VOLLMER RV STORAGE

GRADING AND EROSION CONTROL PLAN

PPR-22-045

Grading and Erosion Control Plan_V2.pdf Markup Summary

COVER SHEET

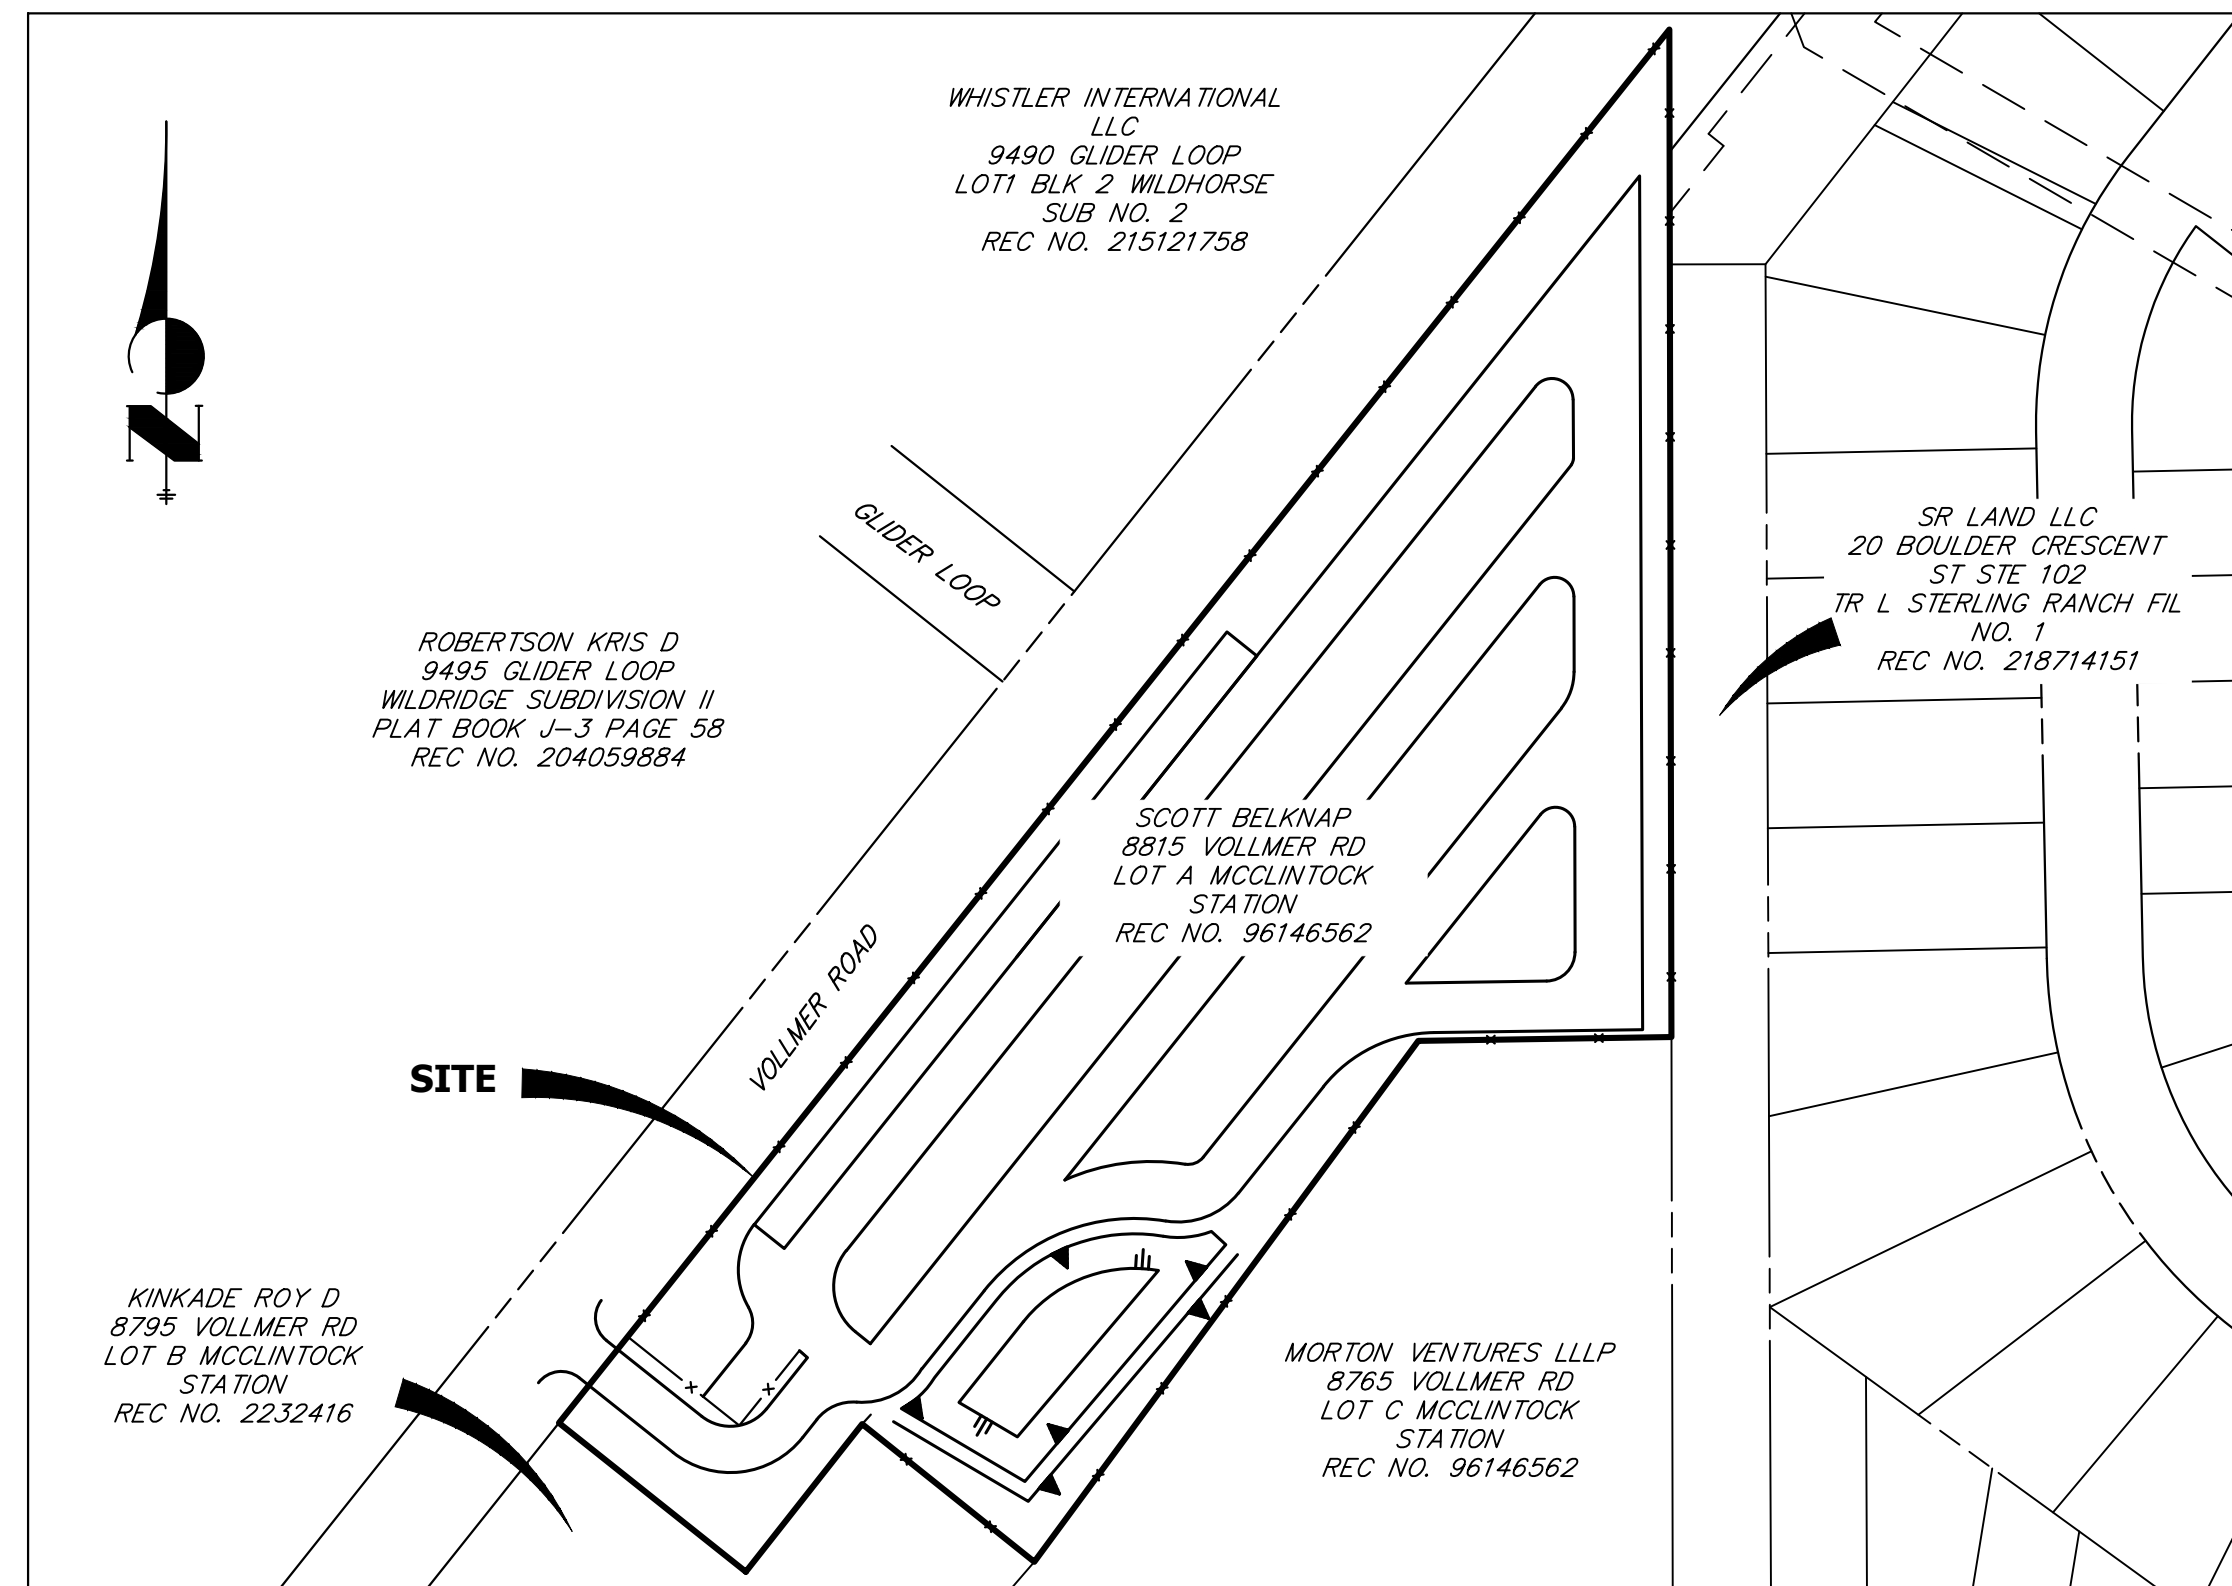
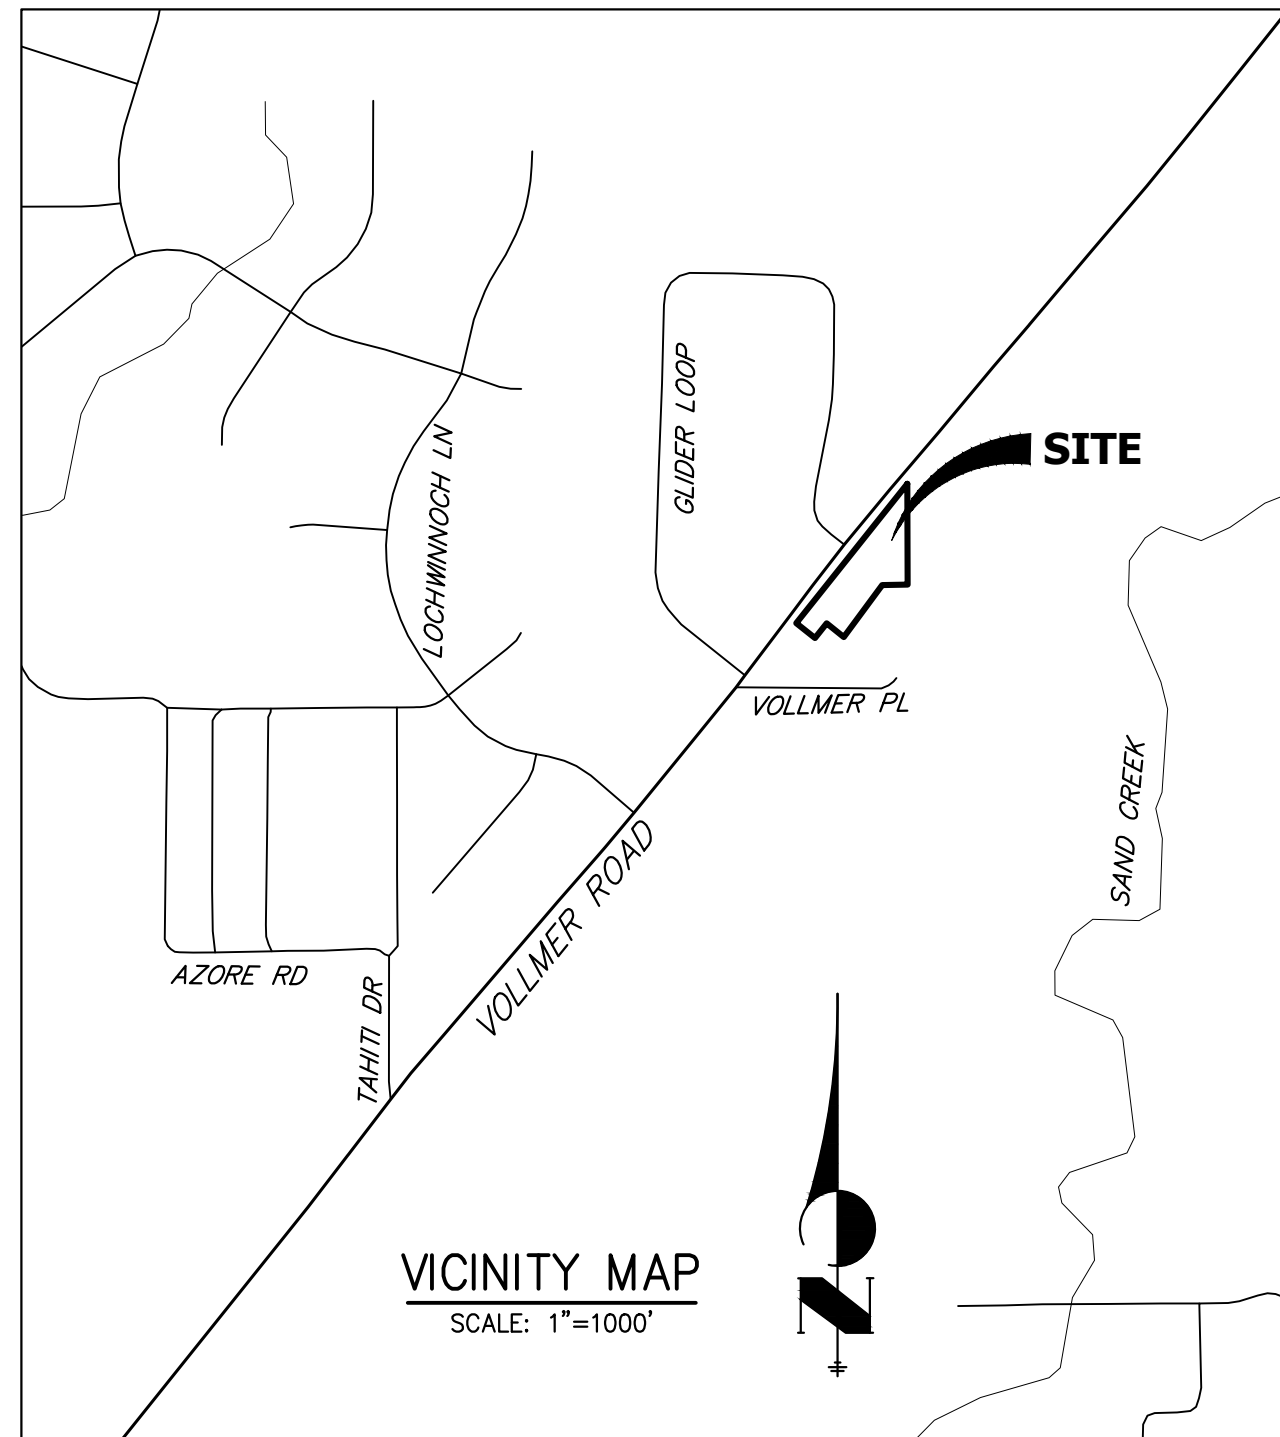
Provide a copy of the soils/geotech report for reference and recommendations for pond embankment.

VOLLMER RV STORAGE
EROSION CONTROL PLAN

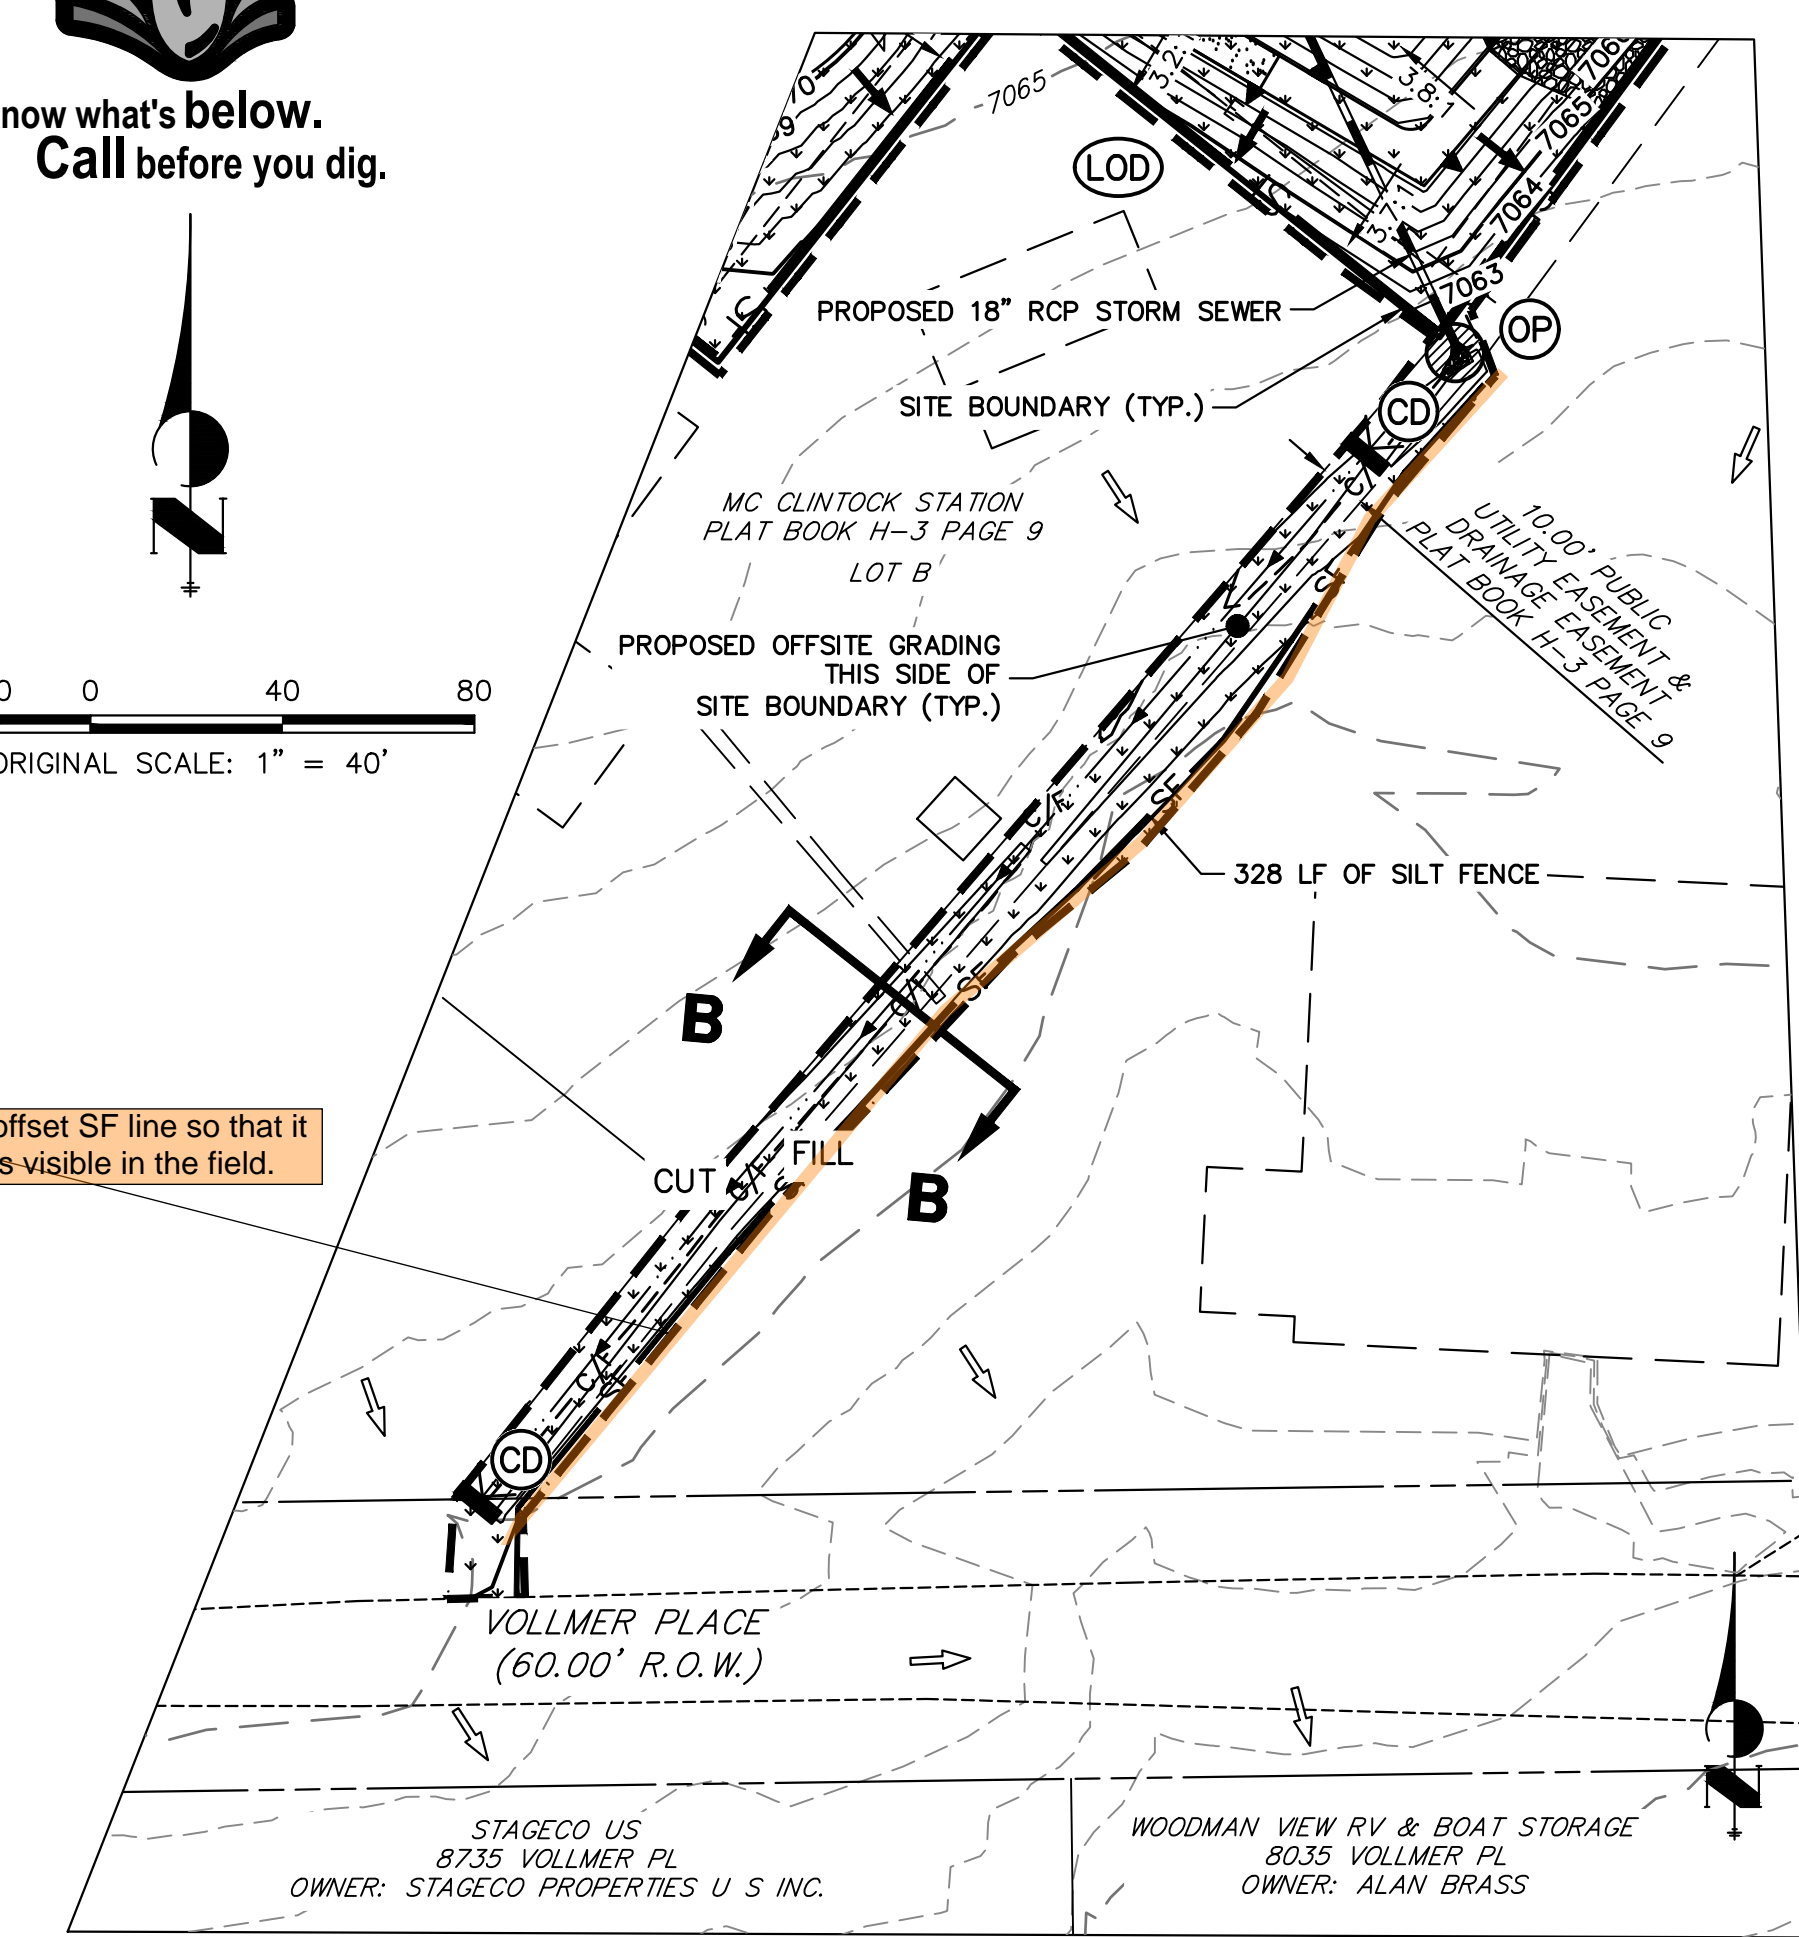
offset SF line so that it is visible in the field.

Determine if there is sufficient cover for this culvert.

Label boundary, lengths & bearings

Label boundary, lengths & bearings
